To: John McDonough, City Manager

Agenda Item: **ZM11-005/CV11-007 201 Mount Vernon Highway**, Request for a zoning modification to the conditions of zoning cases Z93 -030 and ZM08-016/CV08-034.

Zoning Modification Petition No. ZM11-005/CV11-007

PROPOSED SITE PLAN

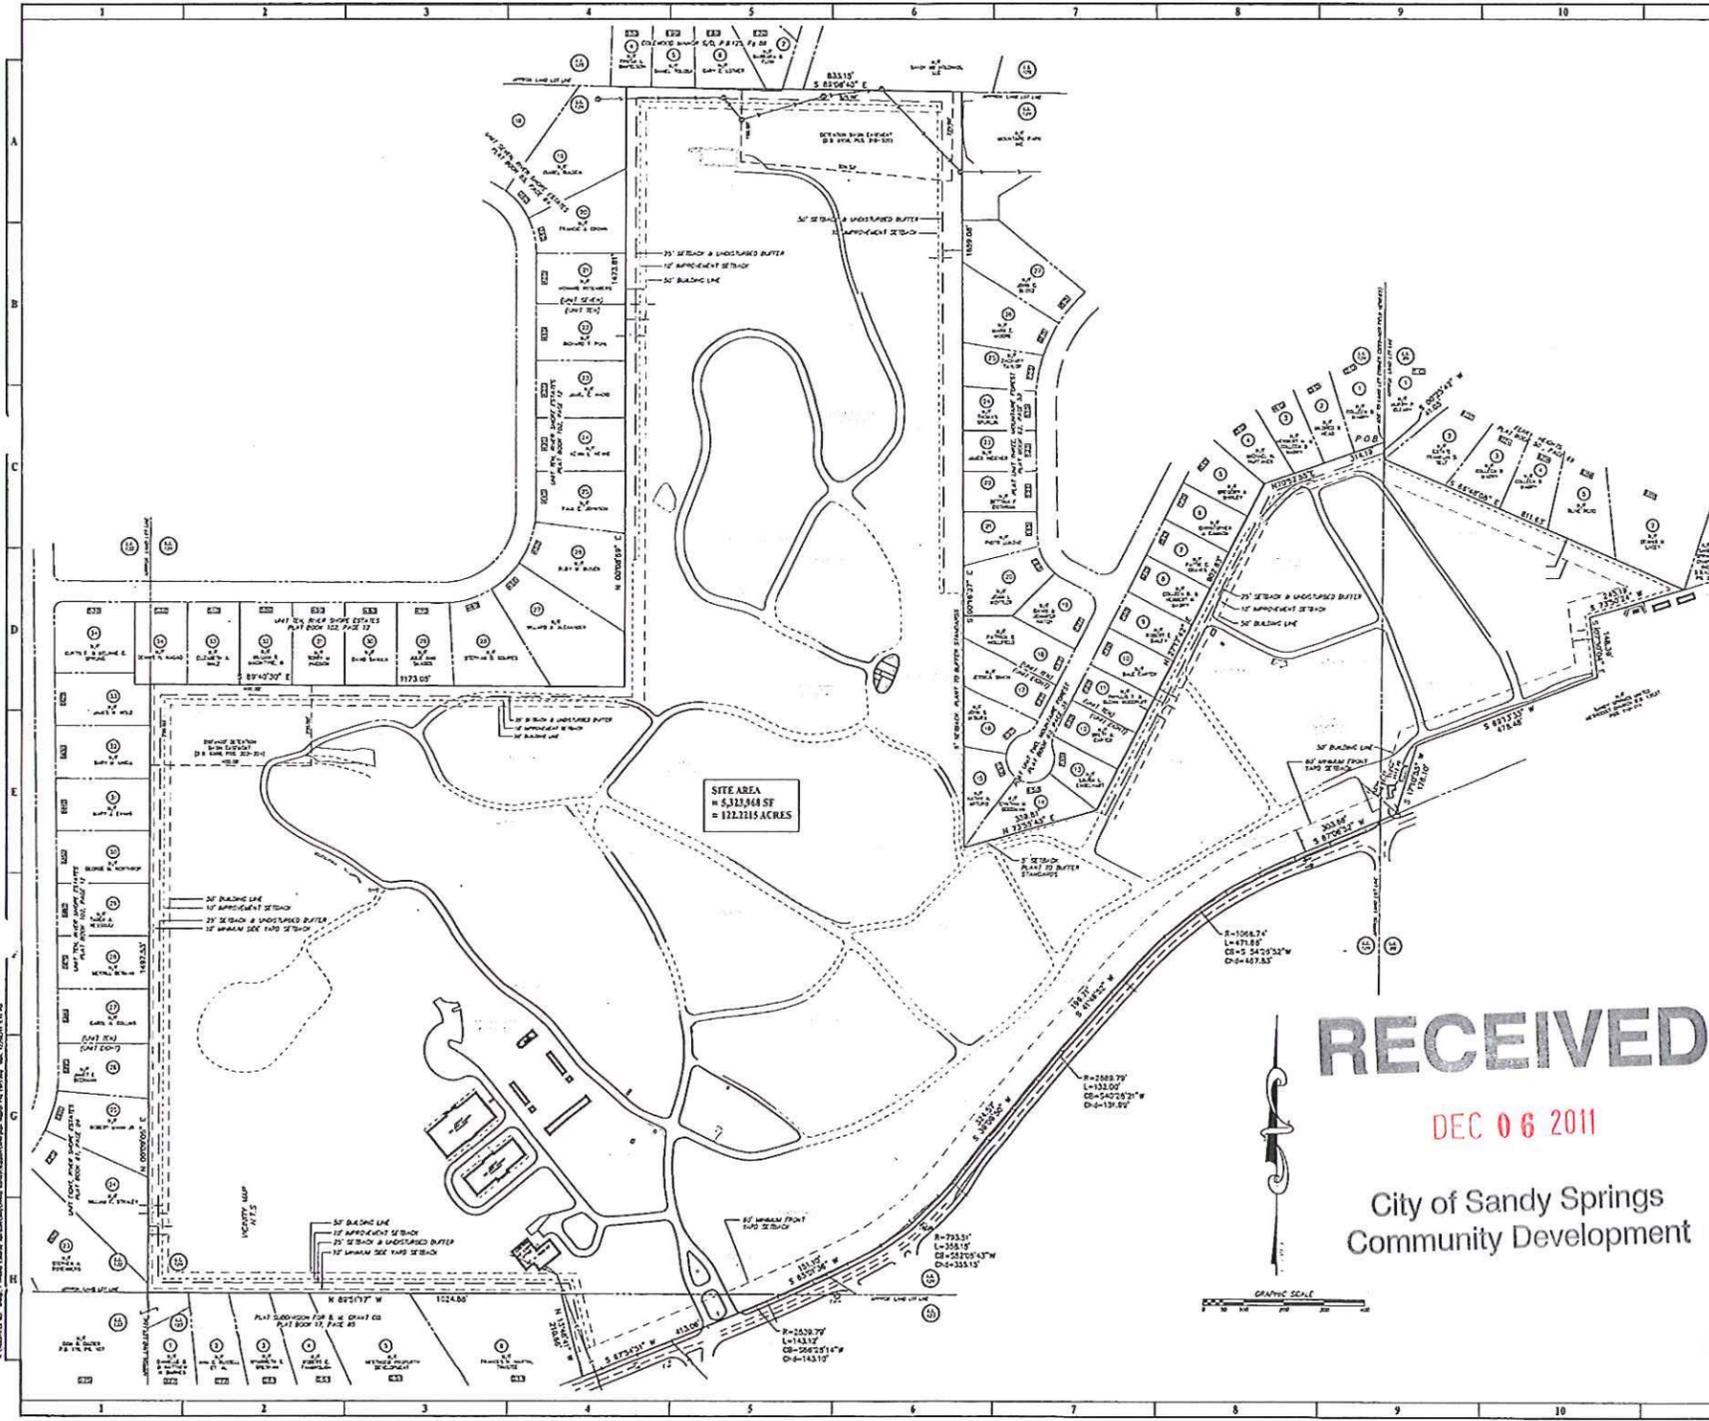
The staff is of the opinion that the request to amend the approved site plan is warranted and is in harmony with the intent of the Zoning Ordinance. The staff is aware of concern and opposition to this application from nearby property owners in that the relocation and construction of the internal drive might negatively affect water quality and stormwater drainage onto adjacent properties. The applicant has submitted an "Arlington Cemetery Master Hydrology Report" that includes a proposal to increase stormwater detention capacity to result in post-development peak stormwater discharge rates that do not exceed current peak discharge rates for the 1, 2, 5, 10, 25, 50, and 100 year design storm events, in accordance with current design standards, upon completion of the cemetery expansion at the west end of the cemetery. Permits for future development shall also comply with current water quality standards. The Master Hydrology Report is in the file as a matter of record. Therefore, based on these reasons the staff recommends APPROVAL CONDITIONAL of the modification of this condition.

2. To the owner's agreement to abide by the following:
 - a. To the Site Plan received by the Zoning Department of Community Development on ~~February 3, 2009~~ **December 6, 2011** and to submit to the Director of Public Works for approval, prior to the approval of a Land Disturbance Permit, a revised Site Plan based on a certified boundary survey of the entire property zoned, incorporating the stipulations of these conditions of zoning approval and meeting or exceeding the requirements of the Zoning Resolution. (ZM08-016)

- n. No mausoleums or estate lots (impervious markers) shall be within the 75 foot stream buffer as shown on the site plan received by the Department of Community Development on December 6, 2012.

DRAWING TITLE
**GRADING & DRAINAGE
 DETENTION POND**

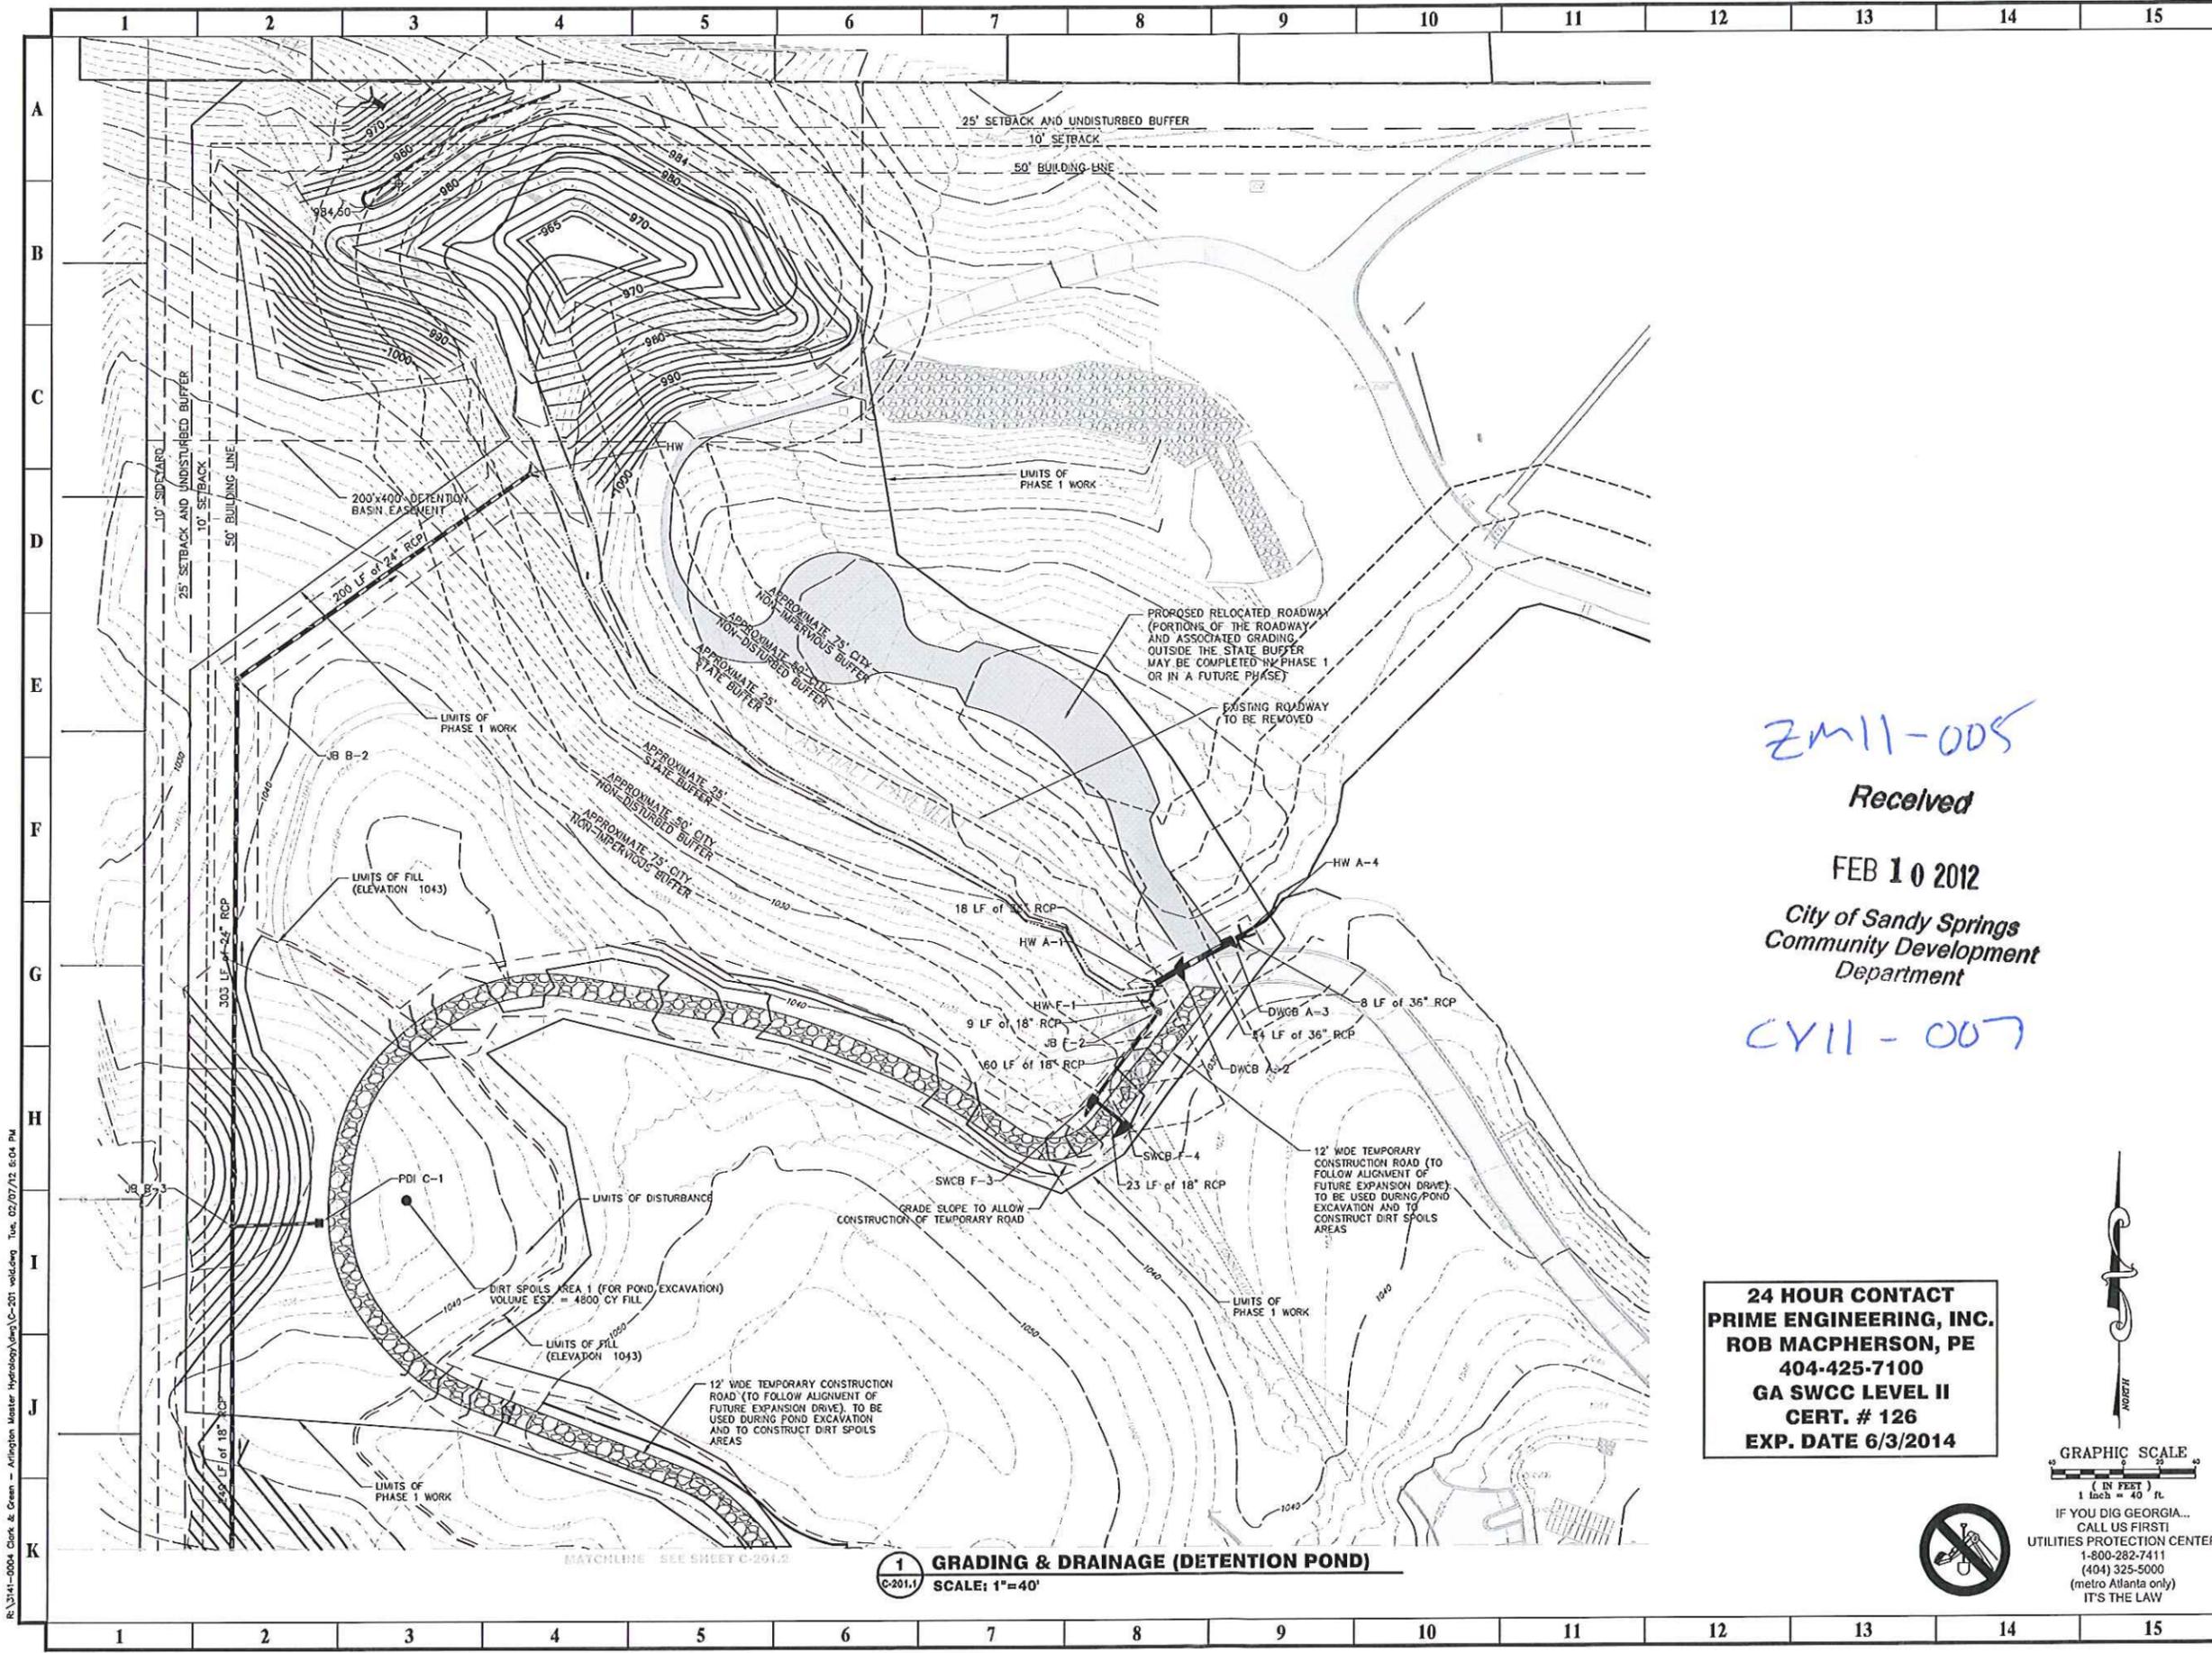
Sandy Springs Chief Environmental Compliance Officer	<ul style="list-style-type: none"> The proposed encroachment into the stream buffer will facilitate work in the detention pond to correct current deficiencies.
CODE ENFORCEMENT	Officer	<ul style="list-style-type: none"> There are no maintenance code violations.
FIRE DEPT.	Sandy Springs Fire Protection Engineer	<ul style="list-style-type: none"> There are no Fire Department requirements that need to be addressed at this time.
TRANSPORTATION	Sandy Springs Transportation Planner	<ul style="list-style-type: none"> Public works has reviewed the petition and does not anticipate the modification will have an adverse impact on the existing streets or transportation network.
	Georgia Department of Transportation	<ul style="list-style-type: none"> There are no GDOT requirements that need to be addressed at this time.

My wife and I are very surprised that Arlington plans to significantly increase the size of the detention pond located behind our house and the houses of several of our neighbors on Riverhill and Riverwood. I had heard before that Arlington would be repairing the pond, which seems very appropriate. The post card that we received from the city mentioned a variance to a stream buffer ordinance only. This just did not register with me that the detention pond would be involved.

I have talked with Arlington's engineer, Rob Macpherson several times. I came away from those conversations with the understanding that the variance was only to relocate a portion of an existing road and that all of the rest of the site plan had been previously approved. I did not understand that the detention pond work was also not yet approved. I have walked around the detention pond area and the engineering plans for the new pond will require a great deal of grading

My request is that the pond only be expanded to the minimum size necessary, and that as few trees as possible be removed. Also, that trees be replanted between the pond and the adjacent neighbors to the extent possible.

Would it be possible not to remove the many trees on the back side of the dam? Presently the dam looks like a wooded hill. If it is graded, with all trees removed, it is not going to be attractive.

- b. **Any Land Development Permit related to this Zoning Modification application (ZM11-005/CV11-007) shall include providing detention, compliant with current standards, for the drainage basin containing the proposed development, considering the basin to be fully developed as represented on the Zoning Modification site plan received by the Department of Community Development on December 6, 2011. Any proposed additional development, resulting from approval of this Zoning Modification petition, including work associated with the relocation of the road, shall be contingent upon the owner accepting ownership of the pond and holding the City of Sandy Springs harmless for the pond, its operation, and its maintenance by executing an Indemnification Agreement. Operation and maintenance of detention shall be the responsibility of the property owner.**

- m. Owner's obligation to begin implementation of the improvements detailed in the November 1, 2011 Master Hydrology Report by Prime Engineering and identified as the "Phase 1 Improvements" on the plans attached hereto "Grading & Drainage Detention Pond" numbered C-201.1 and C-201.2 and received by the Department of Community Development on February 10, 2012 (the "Phase 1 Improvements") are conditioned on the issuance of all permits and approvals from any relevant agency needed for such implementation. These include, without limitation, issuance of any variances and permits from federal agencies including the Army Corps of Engineers, any state agencies including the Environmental Protection Division and the Georgia Soil and Water Conservation Commission, Fulton County agencies and the City of Sandy Springs (collectively, the "Agencies"). The City agrees that it will be the named party and applicant requesting approval from the Agencies, such request to be based on Phase 1 Improvement Plans to be provided to the City by the Owner. The Owner's responsibilities shall include and be limited to preparation of the Phase 1 drainage, grading and erosion and sedimentation control plans for the Phase 1 Improvements and payment of application fees and permit fees specific to those plans and the Phase 1 Improvements. The Owner will cooperate promptly and as necessary with any requests specific to those plans made of the City by the Agencies and will pay any fees required in that process. Owner shall begin implementation of the Phase 1 Improvements within 90 days after issuance of all necessary approvals for the Phase 1 Improvements. Owner's obligation to implement the Phase 1 Improvements is further conditioned on receipt of a construction easement from Fulton County to allow implementation of the Phase 1 Improvements. Upon completion and final approval by the Agencies of the Phase 1 Improvements, the Owner shall execute the Indemnification and Maintenance Agreement for Detention Ponds with the City of Sandy Springs and accept a quitclaim deed from Fulton County releasing the County's interest and responsibility to the Owner for maintenance of the County Detention Basin identified as Basin #1 in the master hydrology report and drainage plans.
